REPORT TITLE: 36-40A CULWORTH AVENUE, KILLARA – DEMOLITION

DEVELOPMENT APPLICATION Nº: DA0173/11

RECOMMENDATION: Refusal

Figure 1 Overlay between floor levels

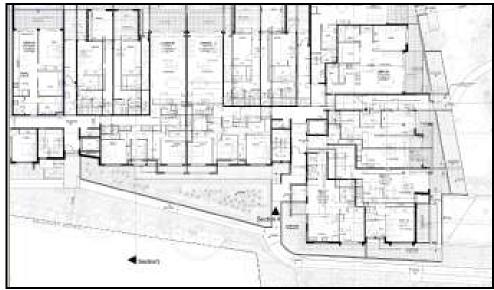
The submitted drawing shows the building footprint in plan view from the third level (FFL188.030). The building footprint represented at this level differs from the building footprint at ground floor and therefore confirmation of compliance with the development standard cannot be determined as represented in **figure 1** below.

The proposal is calculated to result in a site coverage of 36.1% and does not comply with the development standard. No SEPP 1 objection has been made and as it is a development standard, compliance or otherwise must be determined and cannot be conditioned.
